### **OFFICIAL NOTICE AND AGENDA**

Meeting:	ZONING BOARD OF APPEALS
Members:	Nancy Hoffmann, David Burke, Mark Dillman, Dave Oberbeck, Jerry Jarosz, Nan Giese (Alternate), Arlene Kaatz (Alternate)
Location:	Council Chambers at City Hall, 407 Grant Street
Date/Time:	Wednesday, March 15, 2023, at 4:00 p.m.

## **STAFF REPORT**

### Subject: Variance for Athletic Lighting at East High School

## Wausau East Athletic Complex Wausau, WI, USA

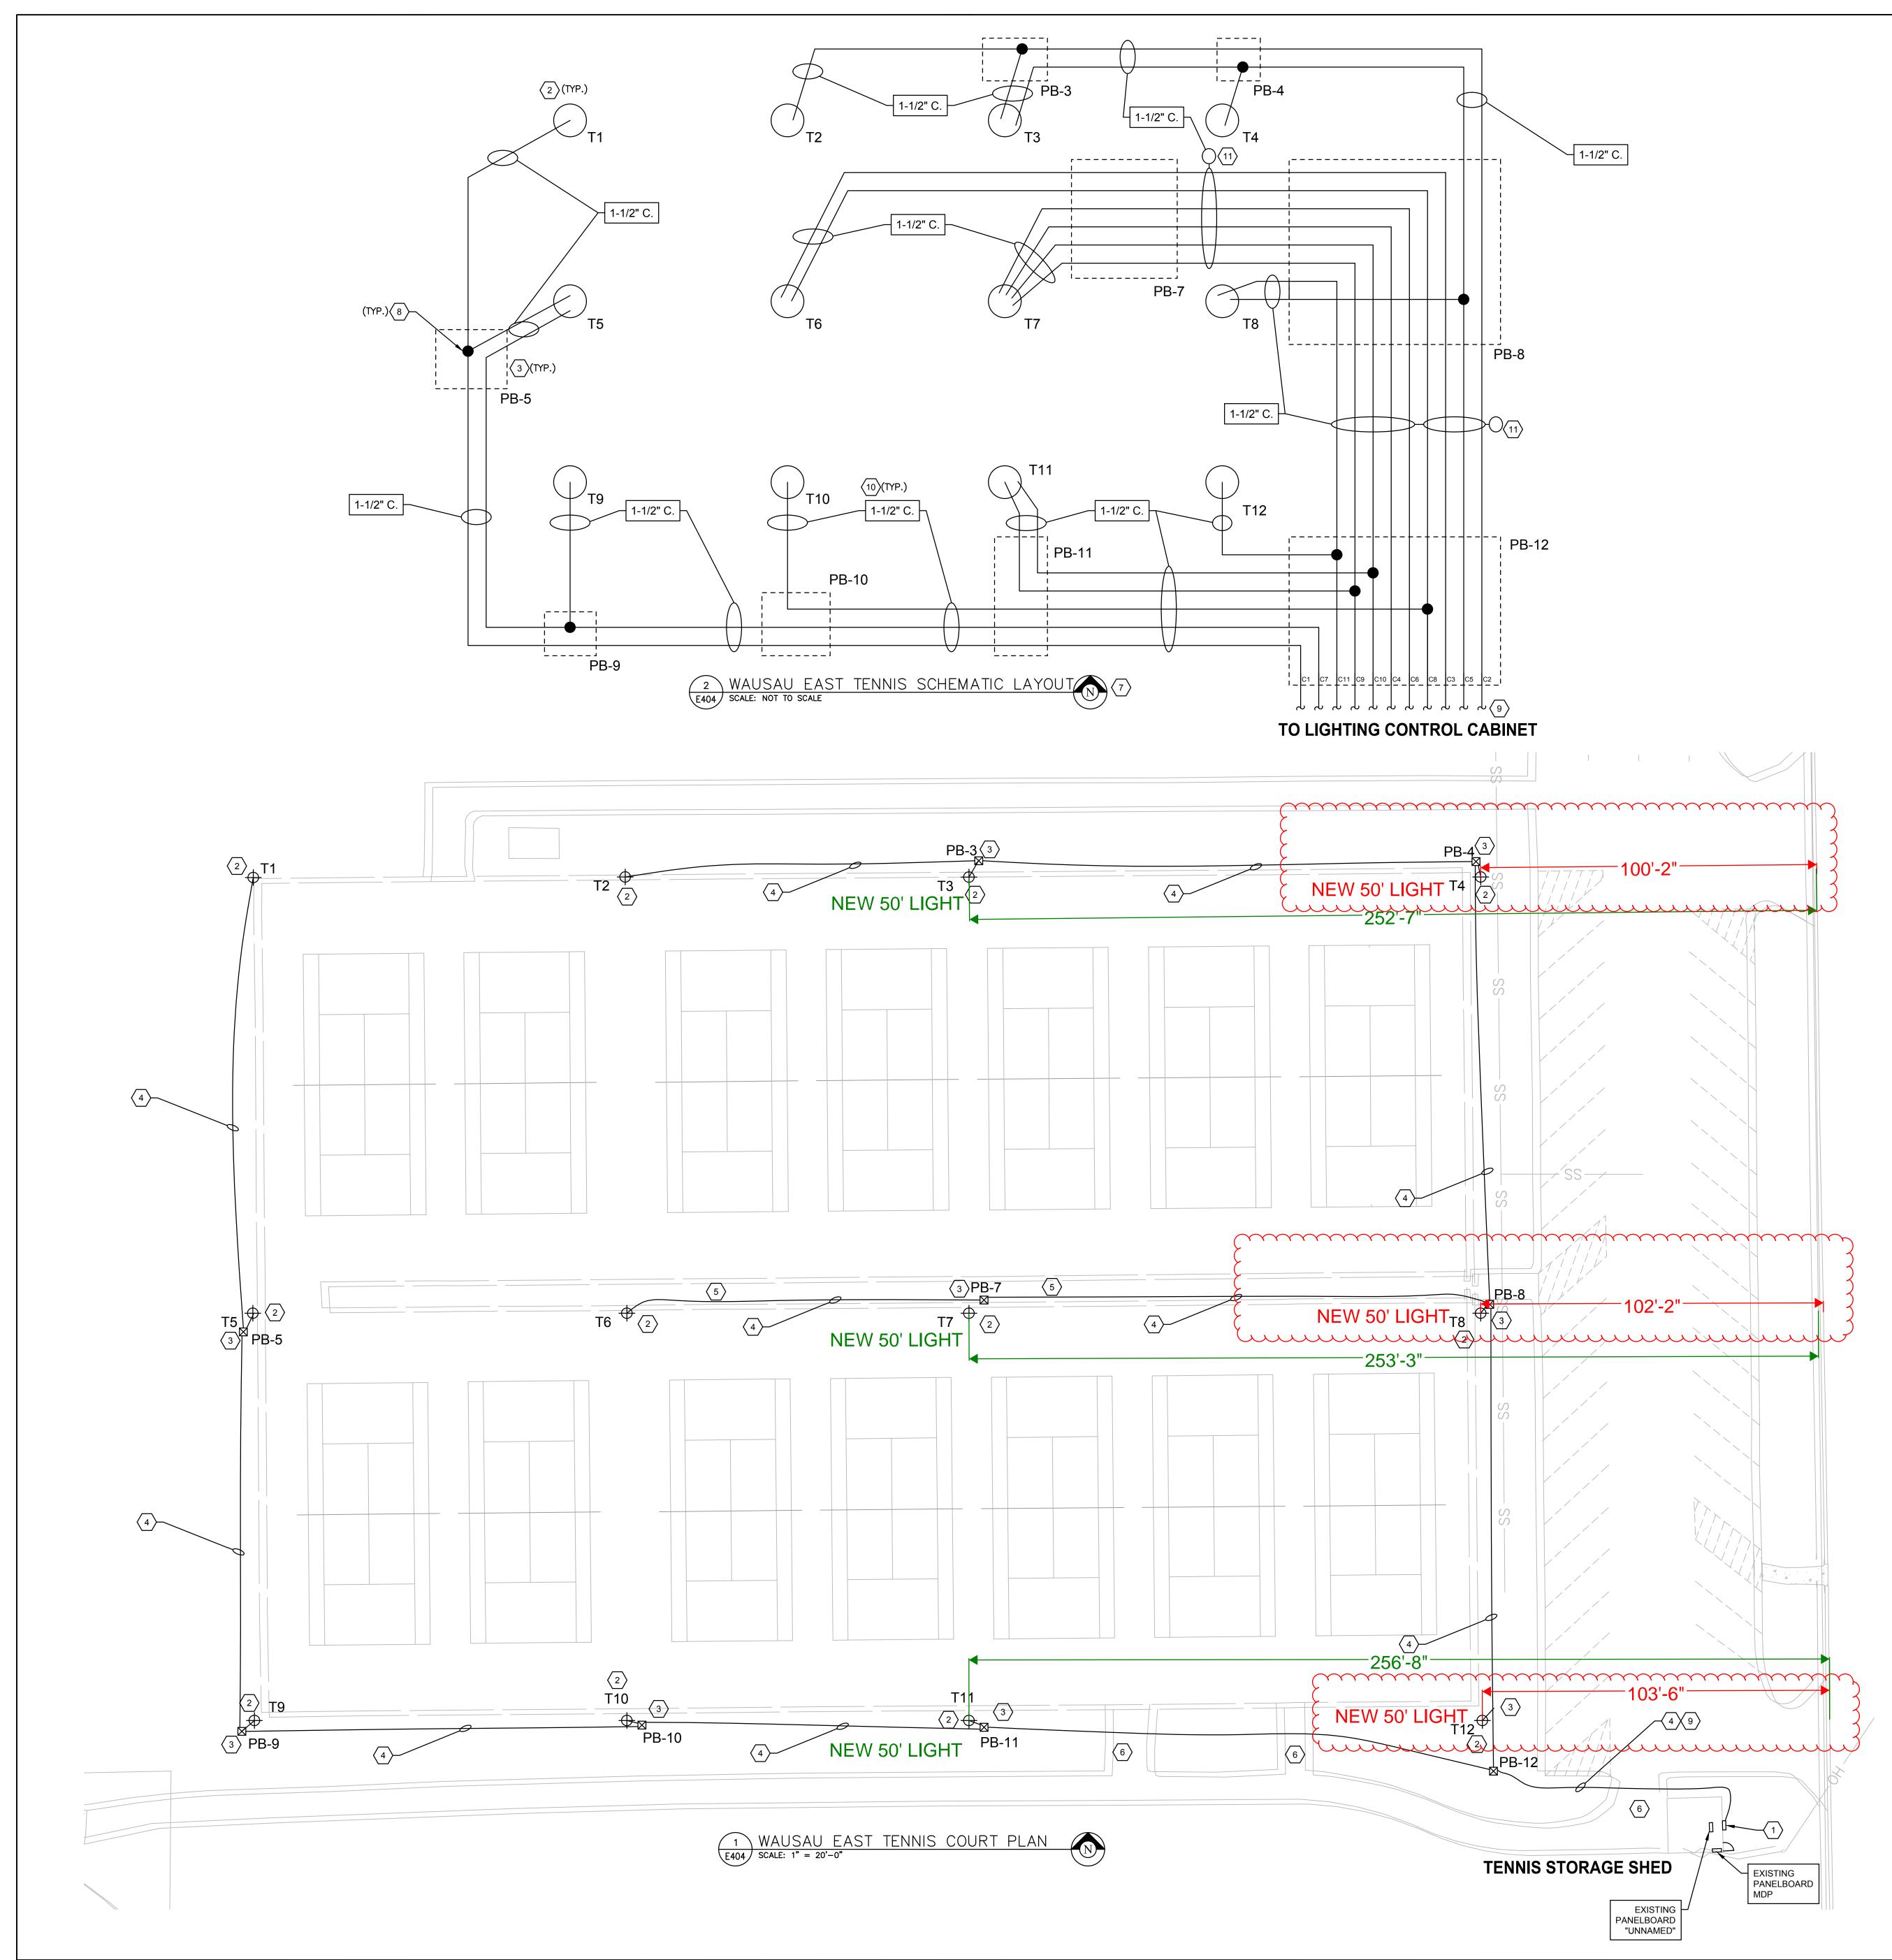
In your packet you will find plans showing the lighting pole height and distance to property lines. Many of the poles that are being proposed are in compliance with the zoning code. Poles that need a variance are clouded around and show pole height and distance to property lines. Also, photometric lighting plans have been included showing that no light spillage will occur over the property lines.

These proposed plans seem to be carefully thought out. Engineered lighting plans have been developed to cut off any light spillage at the property line. The softball and baseball fields have no neighbors close to the fields. The multi-purpose field also has limited neighbors that are impacted. Finally, the tennis court lights are proposed to be placed closer to the property line and public street. This will limit any adverse impact to neighbors on Brown St.
